Multi-Engine Turboprop Communiqué

Communiqué 2001-04 Rev 1
Original Issued November 2001
Revision Issue November 2023

Revision 1 November 2023	ATA 00 – Importing and Exporting Aircraft- Changed company name. ATA 22 – Article deleted. ATA 27 - Universal Travel Board-Added figure to clarify procedure. ATA 32 – Hydraulic Power-pack Parts Breakdown -Part name change from screen to filter. ATA 32 – Foot and Mouth Disease, Wheels and Brakes-Removed, information no longer relevant. ATA 33 – Wingtip Navlight Lense Installation-Updated resin and hardener part number. ATA 33 – Rotating Beacon Replacement-Removed, information no longer relevant. ATA 77 – ITT Harness-Added part number of grommet.
--------------------------	---

Rudder and Tab travel/rigging

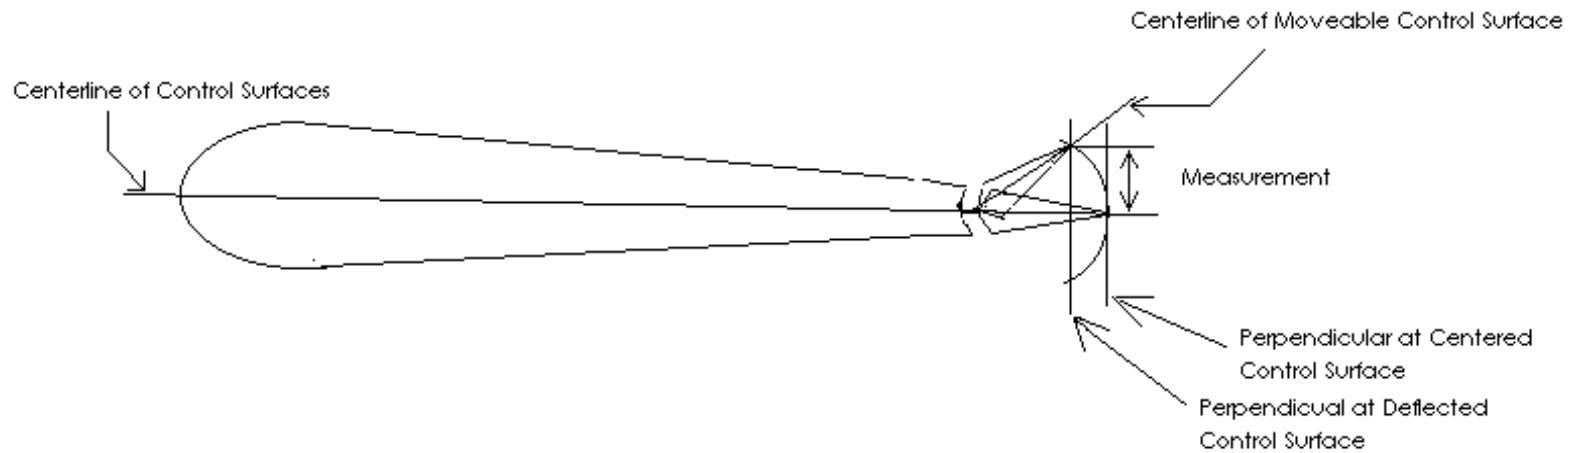
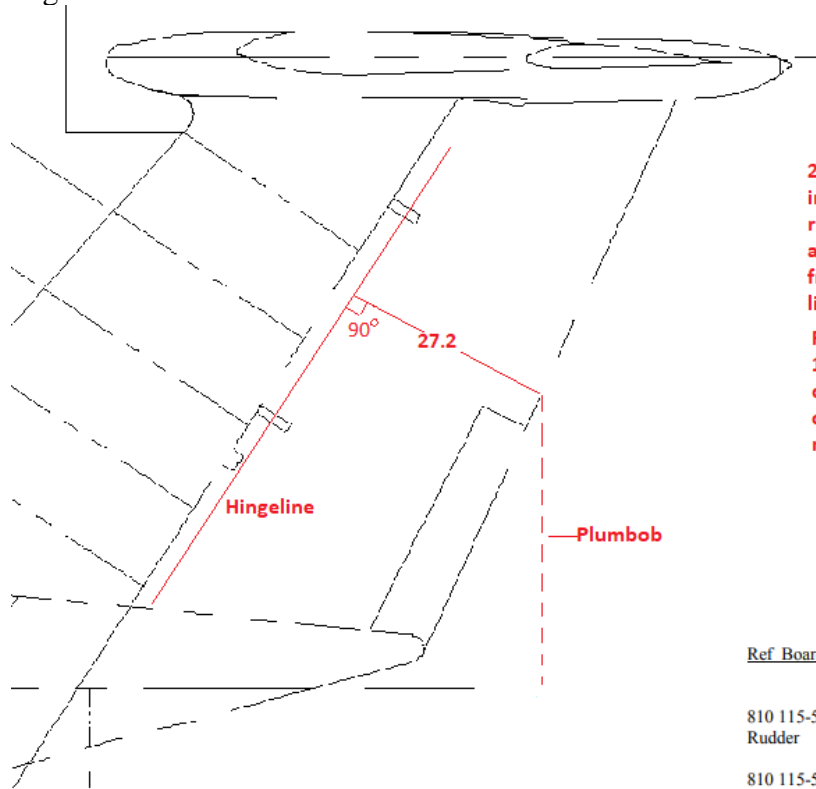
Communiqué 99-005 announced the availability of a Universal Travel Board. This travel board only works on the aileron and elevators. Textron Aviation has developed an alternate procedure to be used for the rudder. This procedure is a simple measurement and does not use the travel board. This measurement is taken with a ruler. See Appendix A.

All measurements are from centerline of vertical stabilizer-rudder-tab in the neutral position. As rudder (or tab) is deflected right or left from the centerline, the measurement will be from (and perpendicular to) the centerline to the center of the trailing edge. Note that as control surface deflection increases, the measurement points move forward.

27.2 inches is the intercepting line of the rudder trailing edge and an extended line from the rudder hinge line.

Resulting deflection of 11.50 expected at 25 degrees from the center line of the rudder.
